Rear Loader Front of Body Hydraulic Tube Replacement

Date: August 31, 2022
Bulletin Name: REL-TSIB-024
Model: Rear Loader (10)
Model Year: 2010 to present
Units Affected: Rear Loader with underbody valves

Figure 1

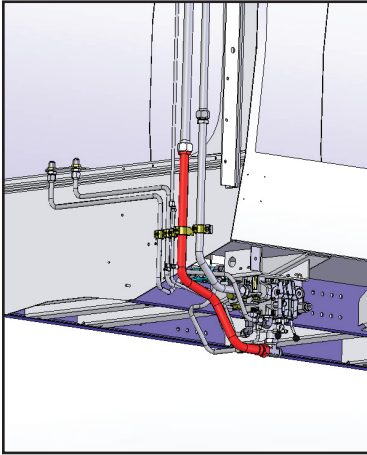
The tube (PN 1137938 or PN 1597692), which may be the subject of repeated failures and repeated replacement, is highlighted in Figure 1.

Figure 2

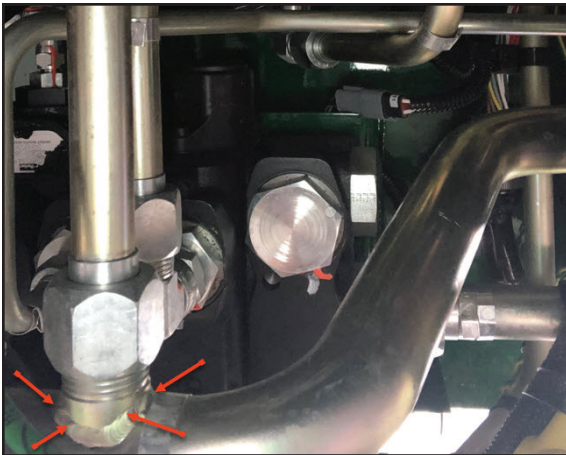
The location of typical failure is at or near the welded saddle port, as shown in Figure 2.

Figure 3

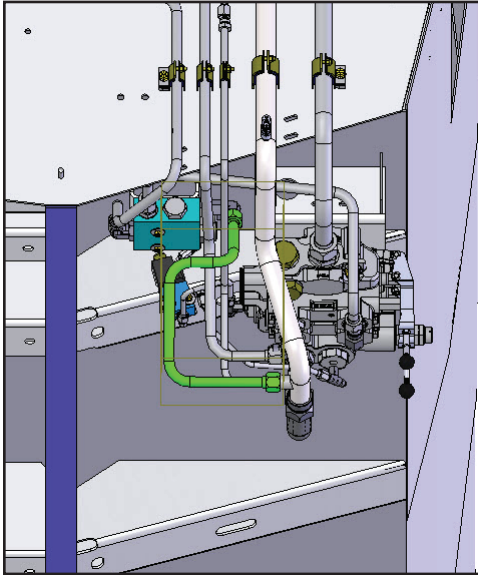
In an effort to help reduce repeated failures on tube (PN 1137938 or PN 1597692), replace the tube (PN 1137935) that connects PN 1137938 or PN 1597692 to the ejector force limiter with a flexible hose (PN 1559615). The location of the ejector force limited tube (PN 1137935) is shown in Figure 3.

1. Perform your company's Lockout/Tagout procedure. If your company does not have a Lockout/Tagout procedure, follow OSHA 1910.147 and 1910.146 Confined Space as appropriate. Chock wheels and engage the service brake.
2. Place an oil collection pan under the tubes.
3. Disconnect the ejector force limiter tube (PN 1137935) (green tube shown in Figure 3).
4. Connect the flexible hose.
5. Use a torque wrench to tighten to proper torque specifications (see Service Manual for torque specifications).
6. Remove your company's Lockout/Tagout procedure. If your company does not have a Lockout/Tagout procedure, follow OSHA 1910.147 and 1910.146 Confined Space as appropriate.
7. Ensure there are no leaks.
8. Dispose of the collected oil according to proper standards and laws.
9. Installation is complete. Return truck to service.
